Ref: **SSD-78156462**
WTJ24-278

SUBMISSIONS REPORT:

Proposed Residential Flat Building including In-fill Affordable Housing

12-16 Bent Street, Lindfield
Lot 3 DP1226294, Lot 1 DP935936, Lot 1 DP960015, Lot 1 DP318518 & Lot 1 DP960014

Redistribution of bulk towards Lindfield Village Hub (Source: PTW, 2025).

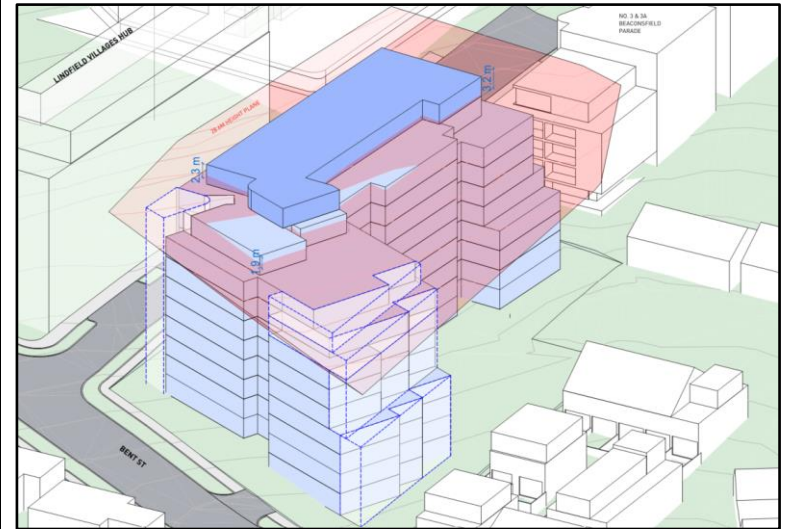
I note that SDRP recommended an increase in height on the northern portion and transitional height on the south-west. However, this should not lead to a height breach with a full floor above 28.6 m.

Additionally, the building encroaches within the stipulated setbacks to the south (Beaconsfield Parade) and 18 - 20 Bent Street.

The height breach coupled with the encroachments within the setbacks implies that the site may not be suitable to accommodate the full GFA that is proposed. In other words, the site may not be suitable for a 3.25:1 FSR.

and 78 units with at least two (2) hours solar access representing 70.3% compliance. Amenity compliance is demonstrated through 1,174m² communal open space and 30.8% deep soil provision, while the strategic justification shows the height variation enables housing diversity and affordable housing cross-subsidisation that strict compliance would prevent, with an estimated 15-20% yield reduction under a compliance scenario.

The Clause 4.6 Variation Request follows the Department's Guide to Varying Development Standards 2023 structure and directly addresses Council's submission concerns regarding environmental planning grounds and site suitability.

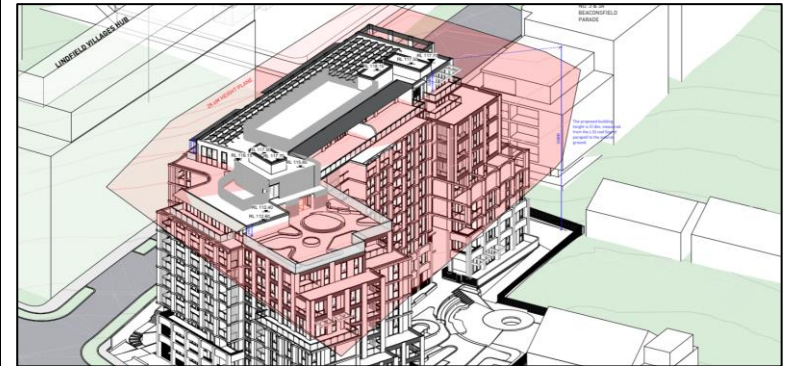
<p><i>However, this is inconsistent with the building height blanket provided within the architectural plans which shows a larger building envelope and a greater extent of height breach (the white area shown in Figure 5). The height breach indicated on the architectural plans is significant and amounts to the majority of the top floor and part of the roof below. For the Clause 4.6 variation request to be well founded, the variation from the development standard must be clearly articulated and justified.</i></p> <p><i>There are no specific objectives associated with building height in Division 1 of SEPP (Housing) 2021. Consequently, the Clause 4.6 variation request addresses the consistency of the development against Chapter 5 of the Housing SEPP. The variation request argues that compliance with the development standard is unreasonable and unnecessary for the following reasons:</i></p> <ul style="list-style-type: none">▪ <i>The proposed development will provide a residential flat building that provides an articulated building form that minimises perceived bulk and scale impacts when viewed from the surrounds of the site. The proposed height and scale of the development is generally consistent with the future character of the area as established by the new built form controls within Chapter 5 Transport Oriented Development in the Housing SEPP.</i>▪ <i>The purpose of the variation is to reduce bulk and scale impacts to the adjoining R3 Medium Density Residential zone. The proposed height variation is consistent with the future intended height of the adjoining E1 Local Centre zone and no additional impacts to bulk and scale will result from the proposed variation.</i>▪ <i>The proposed height will not result in any visual, privacy or overshadowing impacts to the adjoining properties.</i>	<p>The revised Clause 4.6 variation addresses all identified concerns through amendments that respond directly to DPHI's feedback. The variation now demonstrates the height breach results from multiple strategic planning objectives beyond topography, including the Site's strategic TOD location within 400m of Lindfield Station requiring maximum housing yield, its unique interface between four distinct urban contexts, affordable housing delivery requirements under Housing SEPP provisions, and strategic bulk redistribution toward Lindfield Village Hub as recommended by SDRP.</p> <p>Figures 1 and 2 demonstrate the eastern portion height breach responds to SDRP recommendations while maintaining that approximately 90% of built form remains below 28.6m. The variation clarifies that no full floor breach occurs above the 28.6m plane, height exceedances are positioned per SDRP advice, and the design maintains efficient floor plates rather than irregular stepped configurations that would compromise housing delivery. The proposal now reflects FSR 3.19:1, reduced from 3.25:1, directly addressing concerns about site capacity and demonstrating the site can accommodate the proposed density while maintaining amenity standards.</p> <p>The variation acknowledges setback matters have been addressed through design refinements in the Response to Submissions package, with shadow analysis demonstrating no adverse amenity impacts.</p> <p>The Clause 4.6 Variation demonstrates quality planning outcomes through quantified benefits including 111 diverse units, 26 affordable housing units comprising 23.4% of total development, and 78 units with at least two (2) hours solar access representing 70.3% compliance. Amenity compliance is demonstrated through</p>

The applicant has not sufficiently demonstrated that compliance with the standard is unreasonable and unnecessary for the following reasons:

- *The bulk and scale of the development is not appropriate as demonstrated by the insufficient building setbacks proposed and the inappropriate top floor design (inconsistent with Aim (b)(ii) in Section 150 of SEPP Housing).*
- *The development compromises the amenity of the adjoining properties by way of adverse overshadowing impacts. The submitted shadow diagrams (DA-Q3-0020 prepared by PTW dated 3 March 2025) indicate there significant additional overshadowing caused by the 'bonus' GFA and building height ((inconsistent with Aim (b)(iii) in Section 150 of SEPP Housing).*

The Clause 4.6 Variation Request follows the Department's Guide to Varying Development Standards 2023 structure and directly addresses Council's submission concerns regarding environmental planning grounds and site suitability.

Height draped across the roof form demonstrating elements of the built form that protrude through the height plane (Source: PTW, 2025).

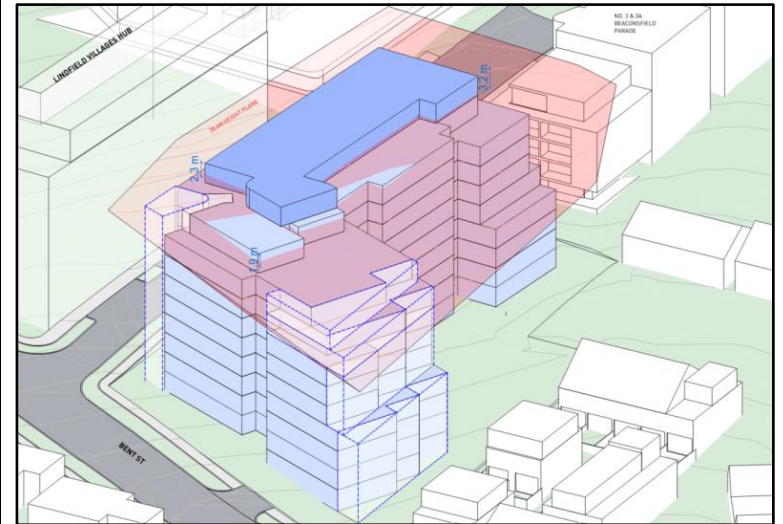
The environmental planning grounds advanced by the applicant are not sufficient for the following reasons:

- *The applicant has not given adequate consideration to the unique circumstances of the site.*
- *The grounds are generic and not specific to the elements of the development that breach the height of building development standard.*
- *The applicant has not sufficiently demonstrated that adverse overshadowing impacts will not result to adjoining properties.*
- *The non-compliant elements are not suitably set back from the boundaries of the site and result in a breach to the site specific building setback controls under the Ku-ring-gai Development Control Plan (KDCP).*

Sufficient environmental planning grounds must be advanced by the applicant to justify the proposed contravention. Greater consideration of the unique circumstances of the site is needed. At pre-DA stage, it was recommended that the height of the building be further reduced in the western part of the site to respond to the neighbouring three storey development; this recommendation has not been adopted. Further, the applicant

The revised Clause 4.6 variation request addresses Council's concerns through consistent height breach articulation with **Figures 1 and 2** clearly demonstrating the breach location. Shadow analysis in amended Architectural Plans (**Appendix C1**) demonstrates two-hour midwinter solar access compliance for neighbouring properties, resolving overshadowing concerns. The

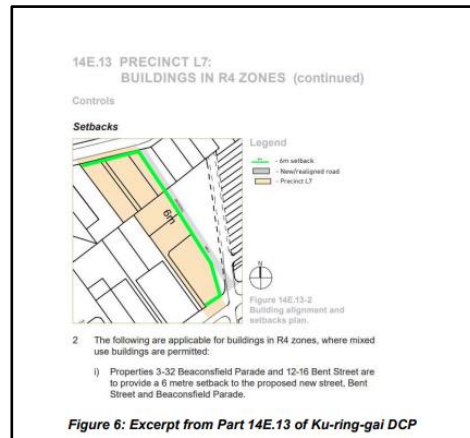
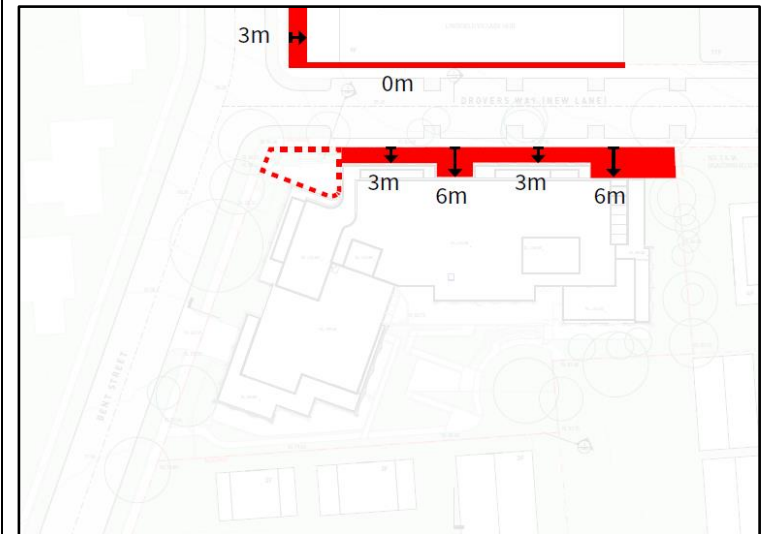
The proposed setback of 3m to future Drovers Way will not create a cohesive streetscape along Drovers Way and is strongly objected to by Council. Compliance with the 6m setback control within the KDCP must be enforced.

A preliminary review of the recently lodged DA at Nos. 3 and 3A Beaconsfield Parade (the site immediately to the south) indicates a proposed 6m setback to the future Drovers Way. Therefore, a 6m setback to Drovers Way must be provided for the subject site to create a cohesive streetscape and enable the planting of tall trees within both setbacks to maintain the landscape character.

The lodged DAs at 3 and 3A Beaconsfield Parade have now been withdrawn, and we cannot base our design on withdrawn designs. It would be more pertinent to match our design with the proposed Lindfield Village Hub setbacks and streetscape.
